FED. ROAD DIST. NO.	STATE	FED. AID PROJ. NO.	FISCAL YEAR	SHEET NO.	TOTAL SHEETS
HAWAII	HAW.	BR-083-1(42)	2009	C.O.20	121

ROADWAY PLAN AND PROFILE

KAMEHAMEHA HIGHWAY - REPLACEMENT OF SOUTH PUNALUU STREAM BRIDGE
Federal Aid Project No. BR-083-1(42)

SHEET No. C21 OF 40 SHEETS

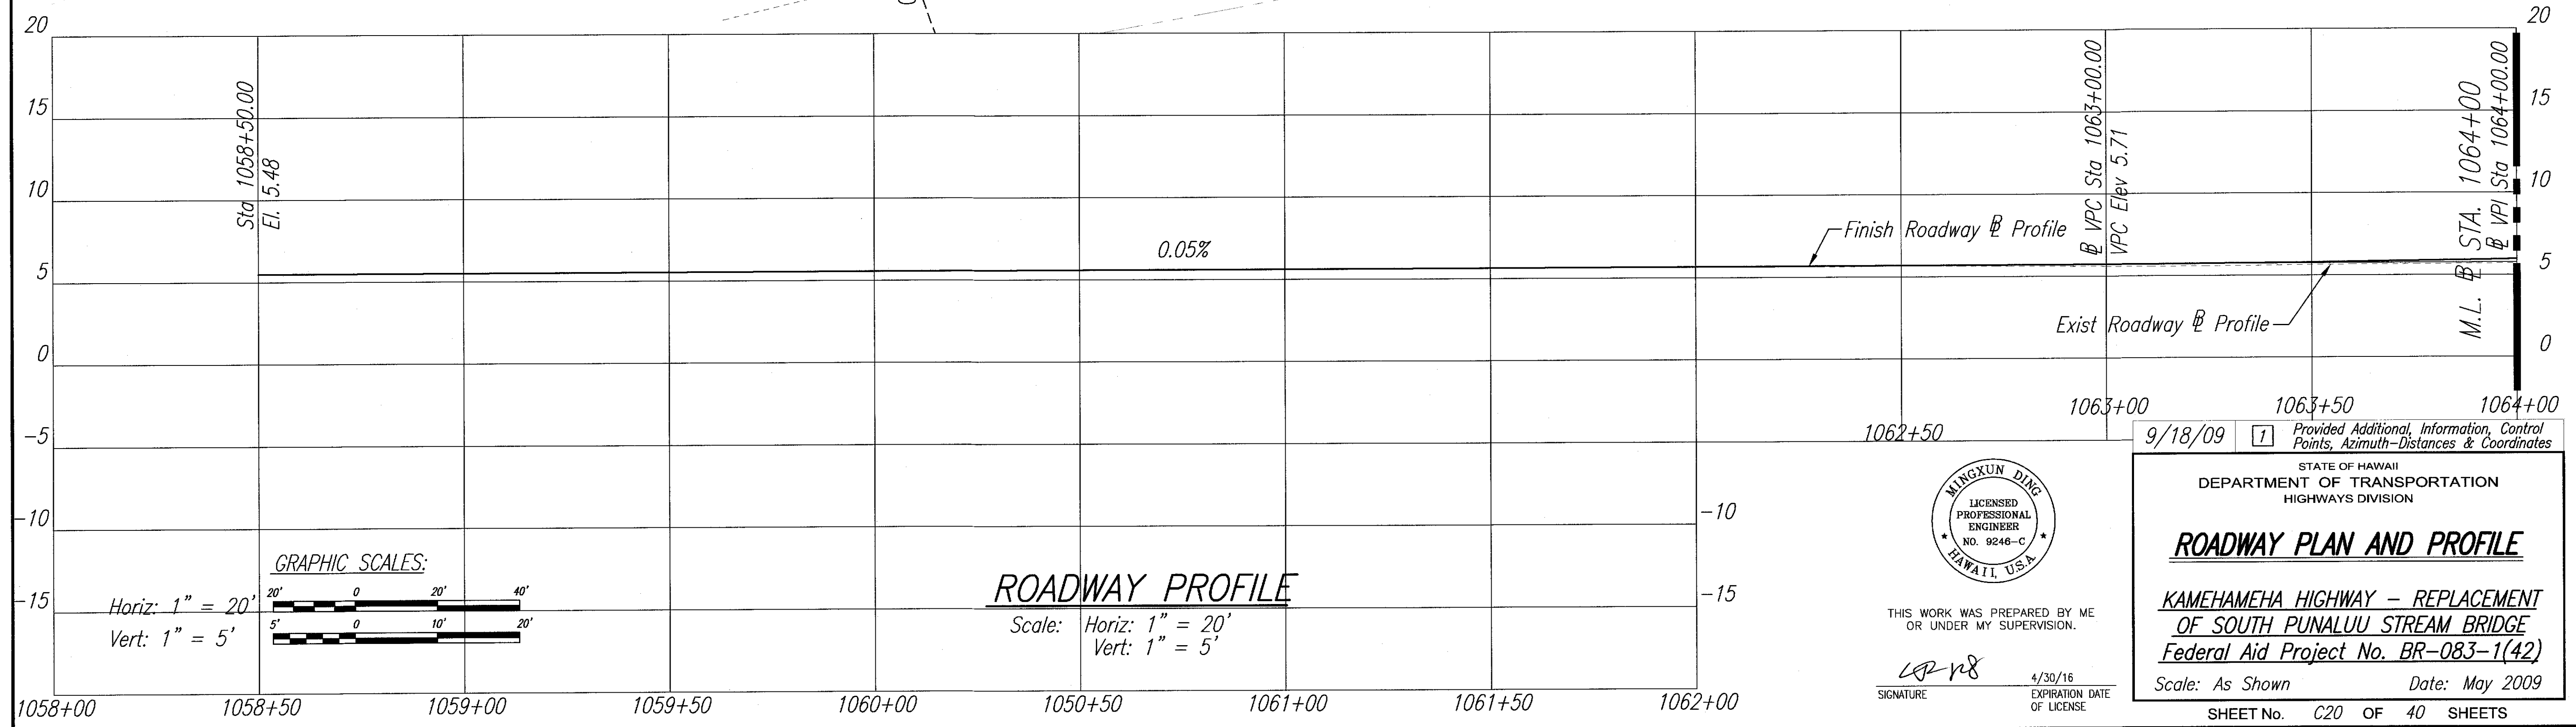
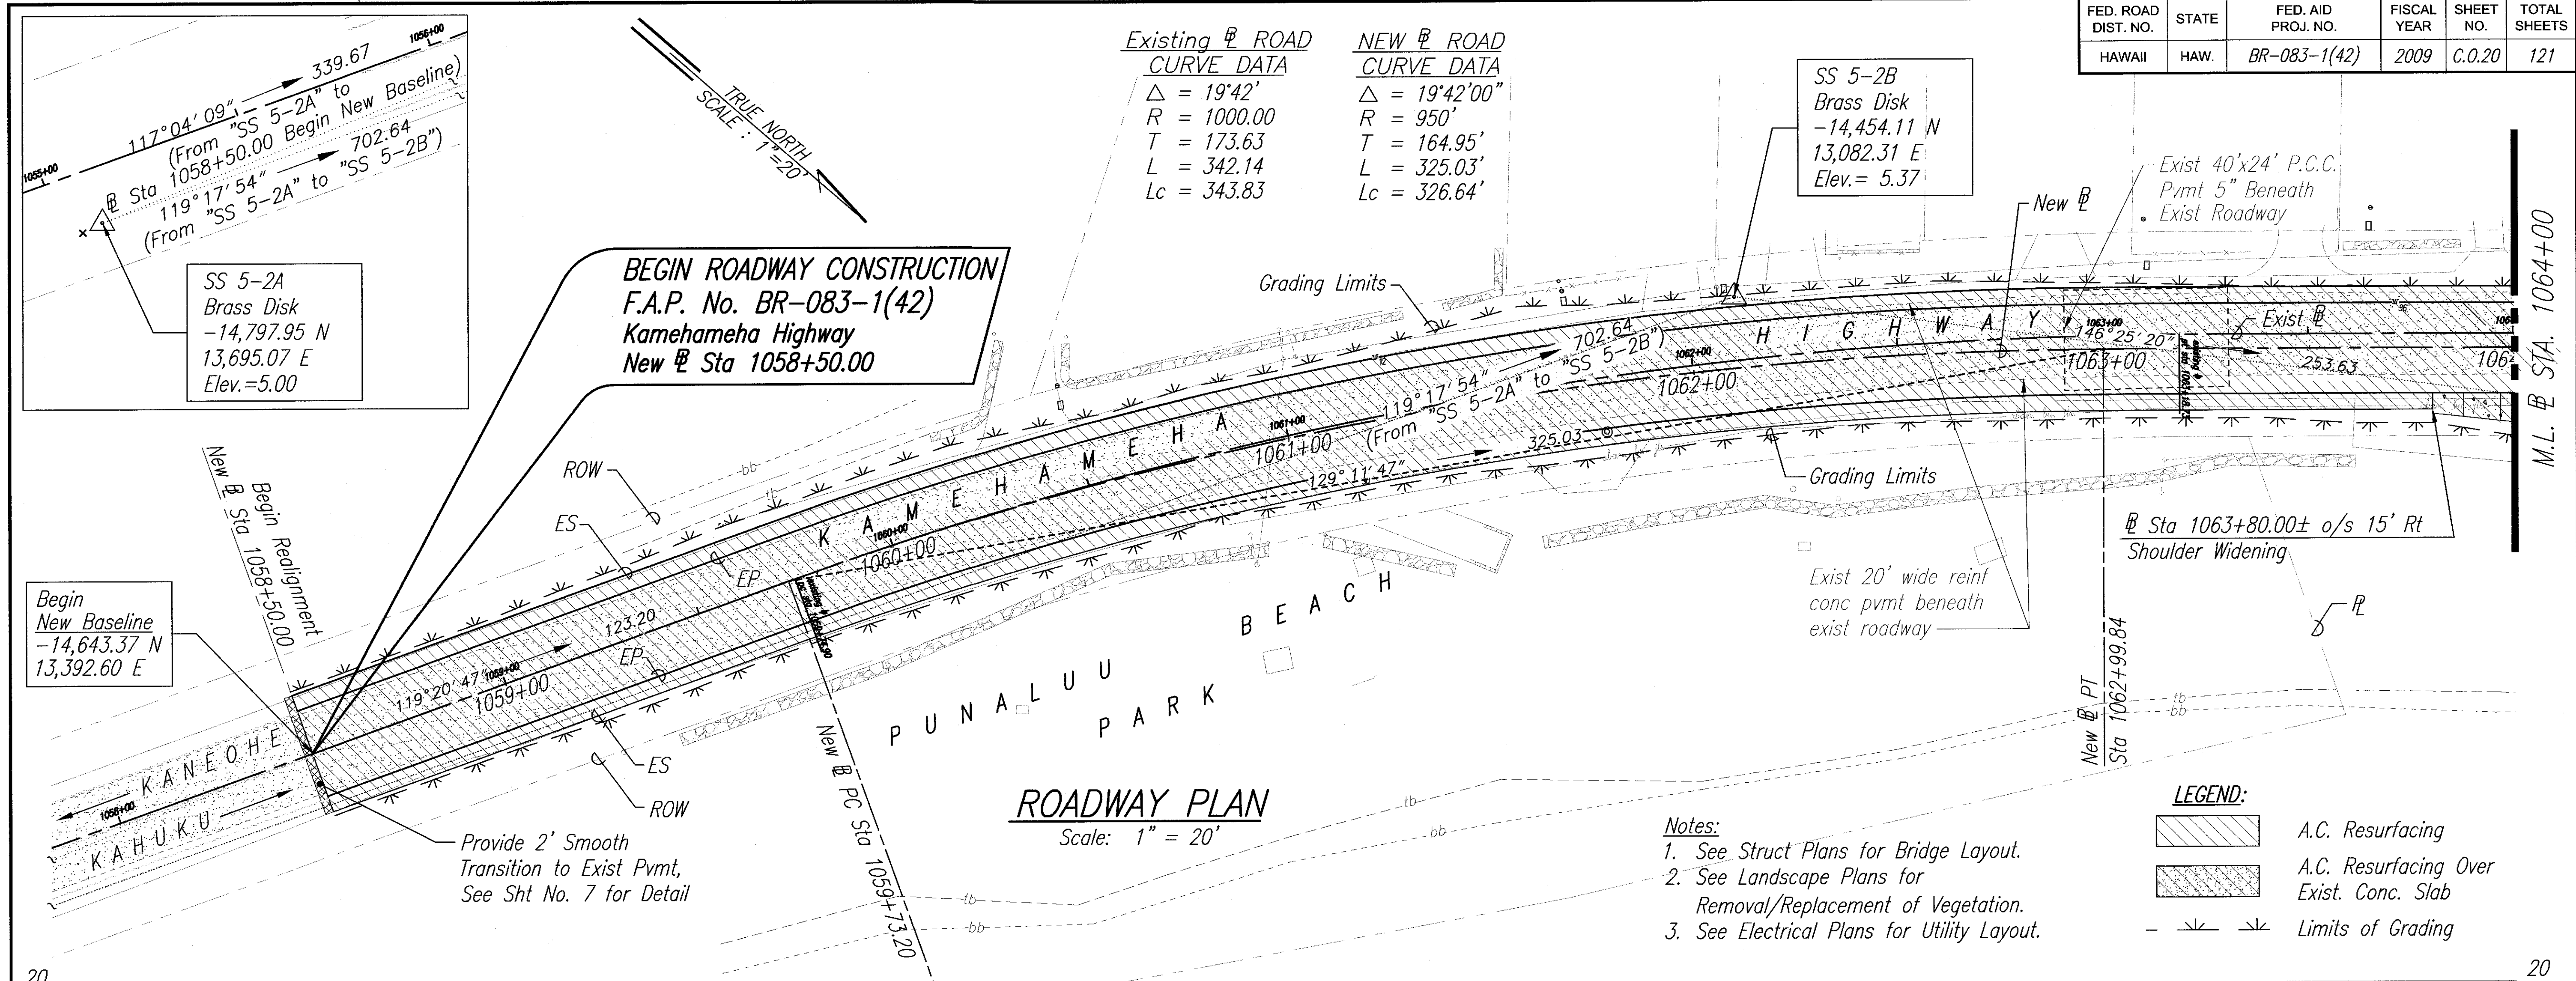
3/26/12	2	A.C. Resurfacing Over Exist. Conc. Slab Revised To A.C. Reconstruction
9/18/09	1	Provided Additional Information, Control Points, Azimuth-Distances & Coordinates

SHEET No. C22 OF 40 SHEETS

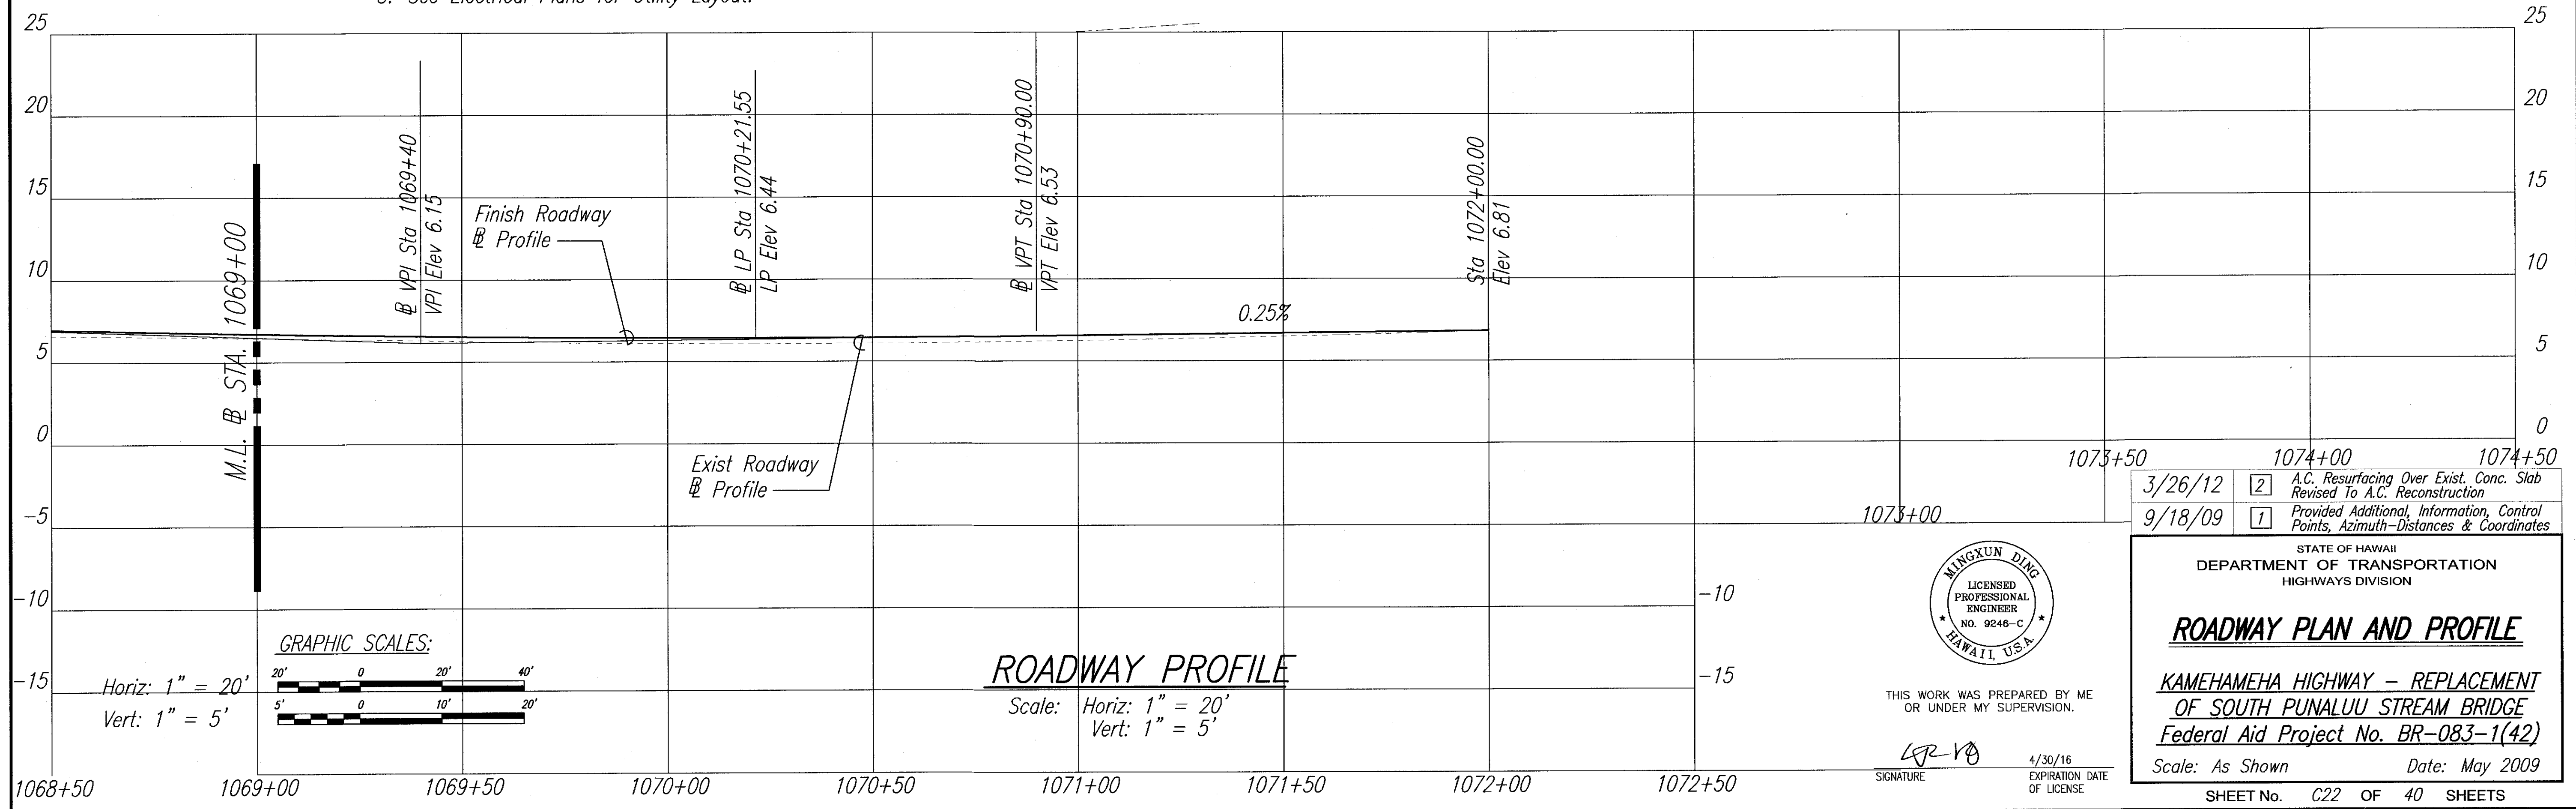
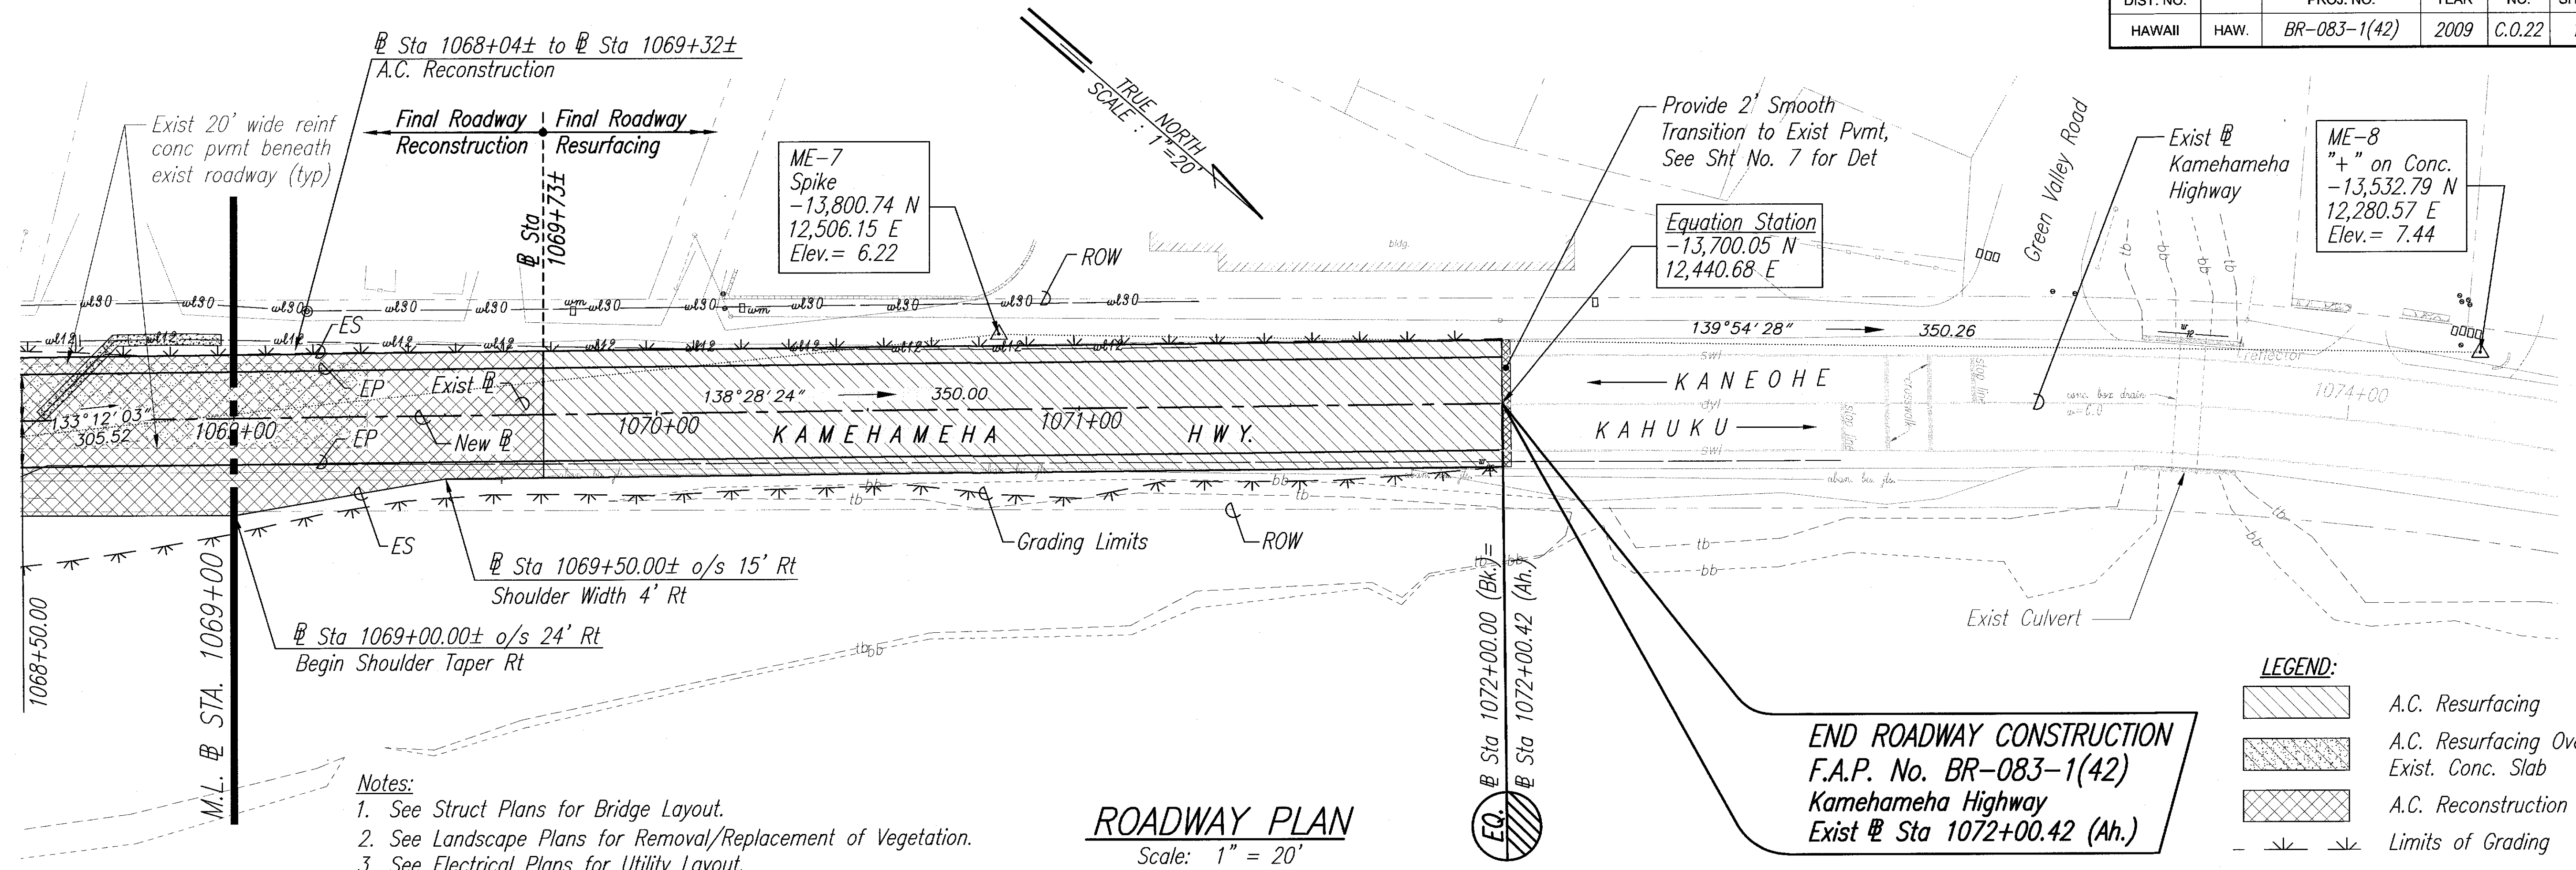
3/26/12	2	A.C. Resurfacing Over Exist. Conc. Slab Revised To A.C. Reconstruction
9/18/09	1	Provided Additional, Information, Control Points, Azimuth-Distances & Coordinates
